Wellington City Proposed District Plan

Hearing Stream 4

Part 3: Local Centre Zone

Section 42A of the Resource Management Act

Kāinga Ora Map 11: Requested Expansion of Karori LCZ

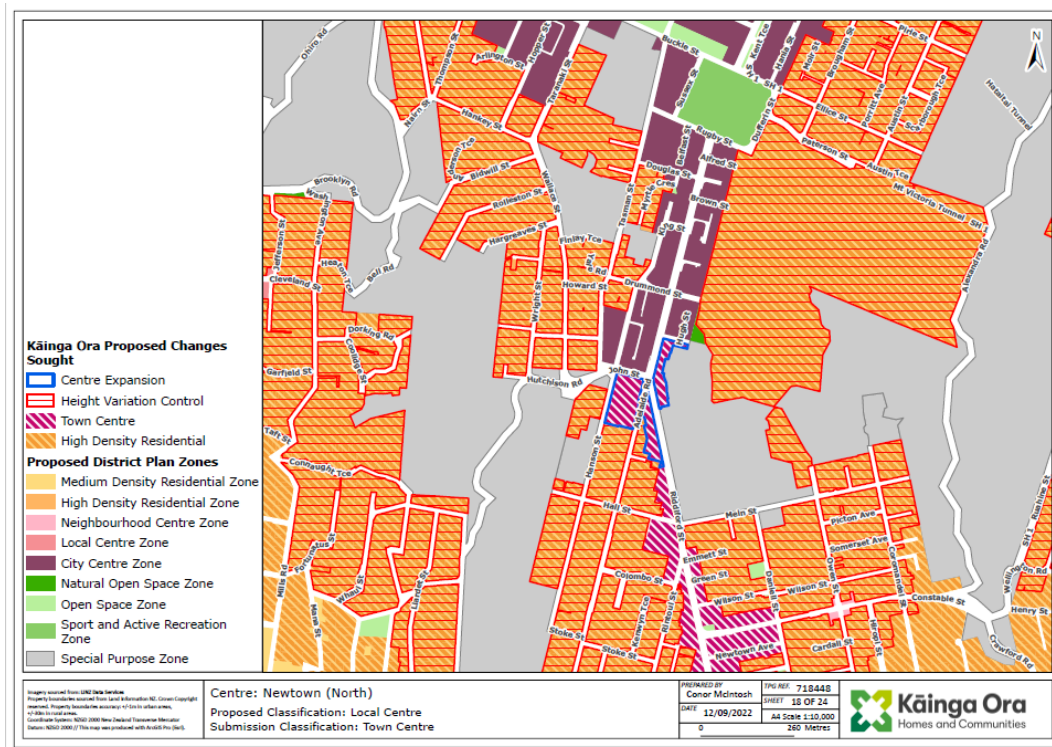
41. As shown below, Kāinga Ora [391.15] also seeks an expansion of the Karori LCZ. This change would also involve rezoning the Marsden Village NCZ as LCZ.

Kāinga Ora Map 18: Requested Expansion of Newtown LCZ

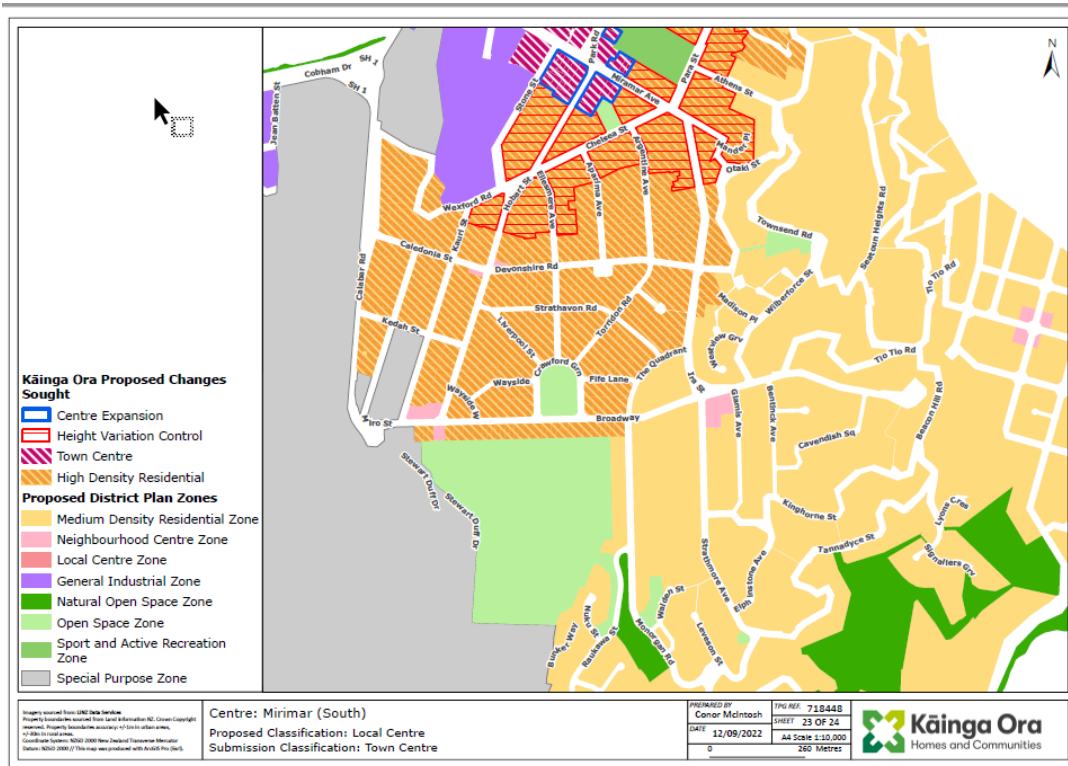
42. James Coyle [307.1] considers that the zone boundary in Newtown is inadequate and should be re-designed by independent professionals to take into account topography, daylight and existing amenities.
43. As well as seeking rezoning of the Newtown LCZ to TCZ, Kāinga Ora [391.15] seeks an expansion of the Newtown LCZ towards the north. This is shown below:

Kāinga Ora Map 23: Requested Rezone and Expansion of Miramar Local Centre Zone

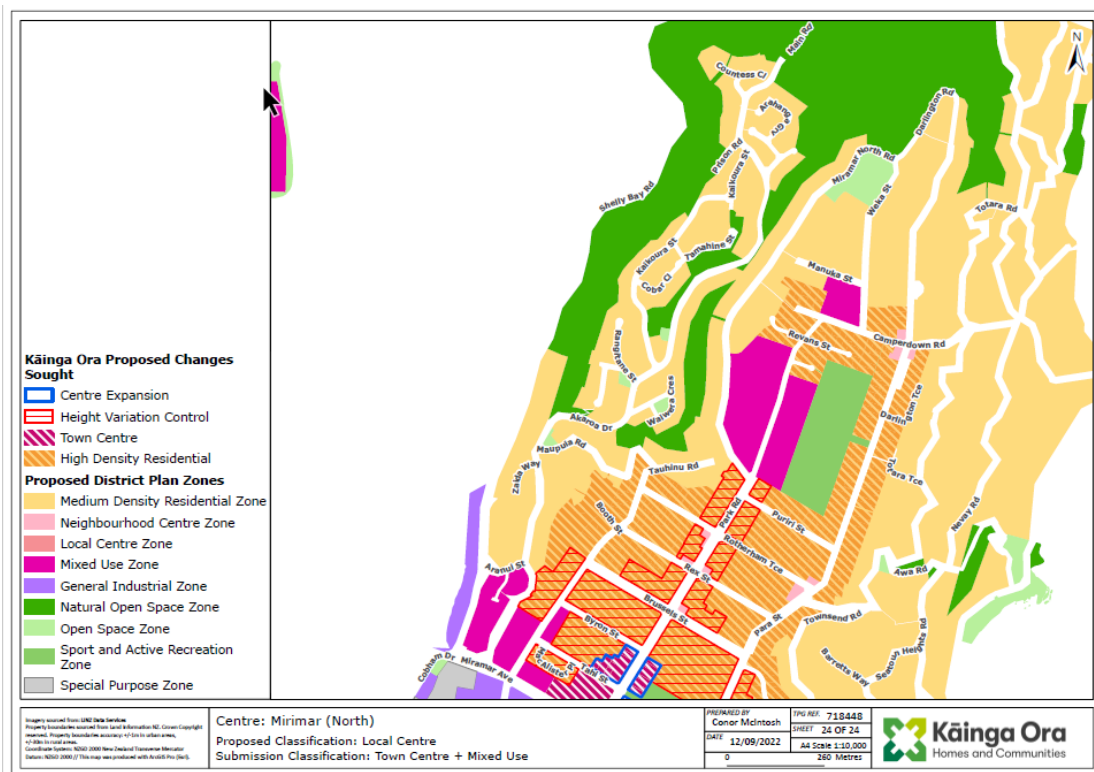
44. In addition to seeking that the Miramar LCZ is rezoned as TCZ, Kāinga Ora [391.15] seeks extensions to Miramar North and Miramar South as shown below:

102. Turning to the extensions to the LCZ as requested by Kāinga Ora (Maps 23 & 24), I note that these sites are currently used for established residential activities. I note that in addition to the LCZ, Miramar contains a significant amount of MUZ land. I do not see a need for additional

Kainga Ora Map 18 – Extension to Newtown LCZ

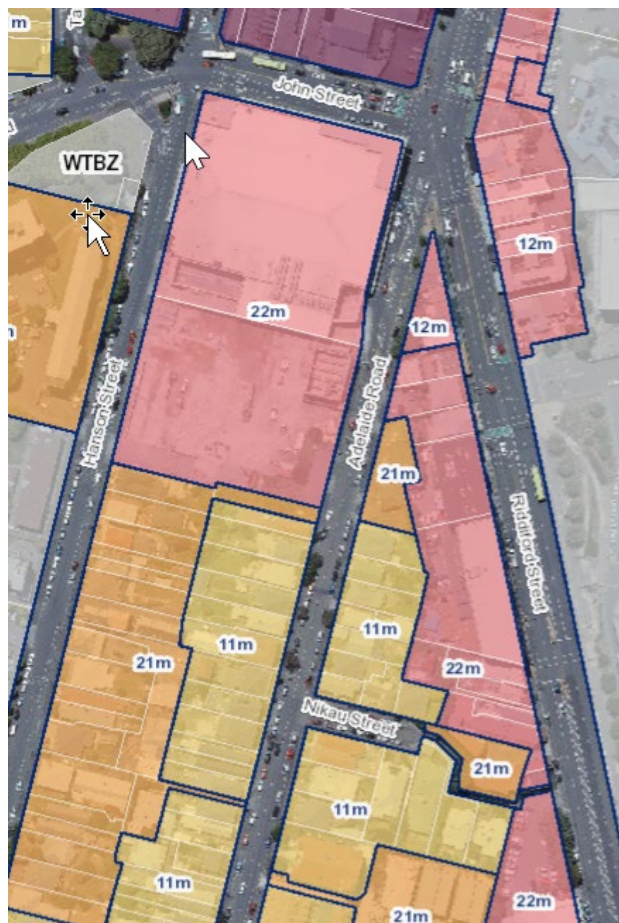
96. The section of Kāinga Ora Map 18 below shows a request to extend the LCZ towards the north. The PDP image to the right shows that this land is already zoned LCZ. It is not clear why this change has been requested; however, in my view no further assessment is required.

97. For the reasons set out above, I recommend that submission points 37.1 and 391.15 (Maps 15, 17, 18) are rejected.

PDP Zoning - Miramar

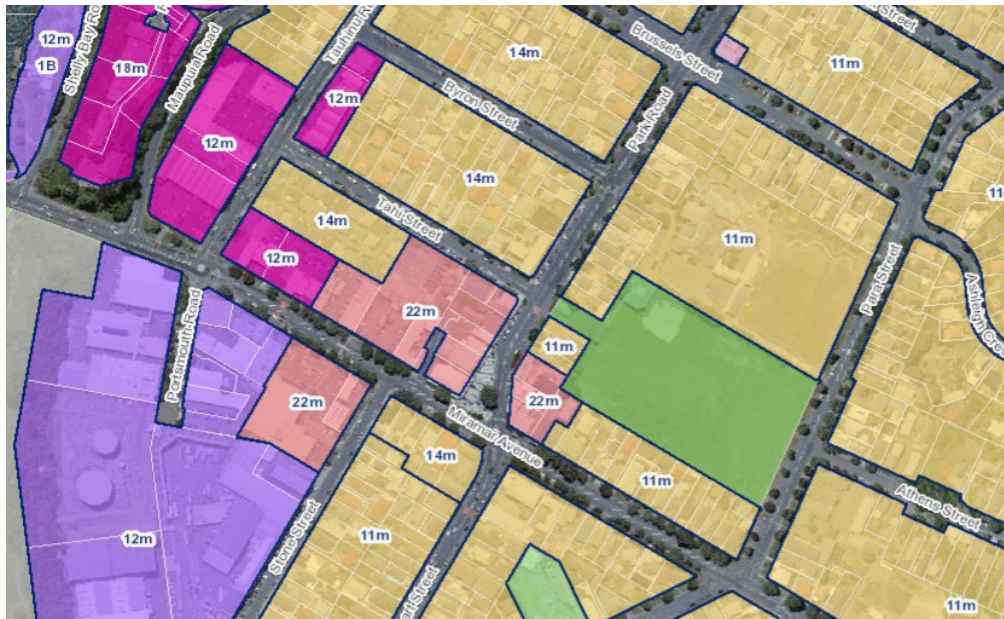
98. Kāinga Ora has requested that the Miramar Centre is rezoned as TCZ and extended (refer to Maps 23 & 24).
99. The Miramar Centre is zoned as a Town Centre in the ODP, with secondary frontage controls applying¹³. The additional parcels of land that Kāinga Ora seeks be rezoned are both zoned Outer Residential Area under the ODP. The proposed PDP zoning is shown below, with the additional parcels zoned MRZ and subject to height limits of 11 and 14 metres.

Proposed Height Control Area Changes for Newtown LCZ

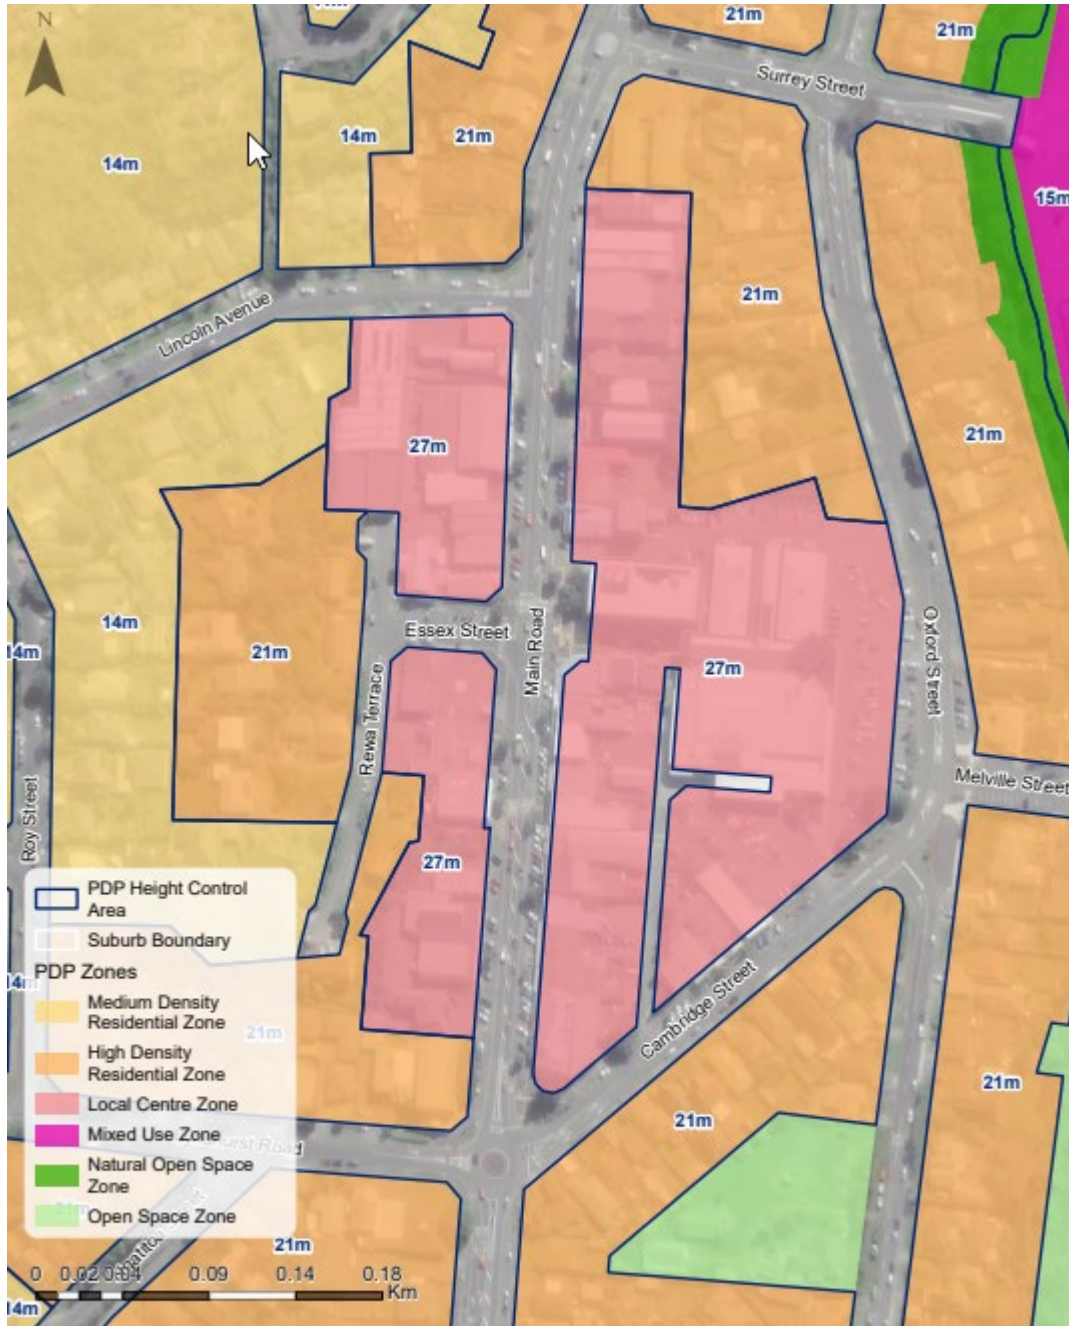
This map shows the proposed height control changes for the Newtown Local Centre Zones (LCZ). It is proposed that the LCZ height outside of the heritage areas be changed from 22m to 27m, and that the LCZ height inside heritage areas be changed from 12m to 18m.
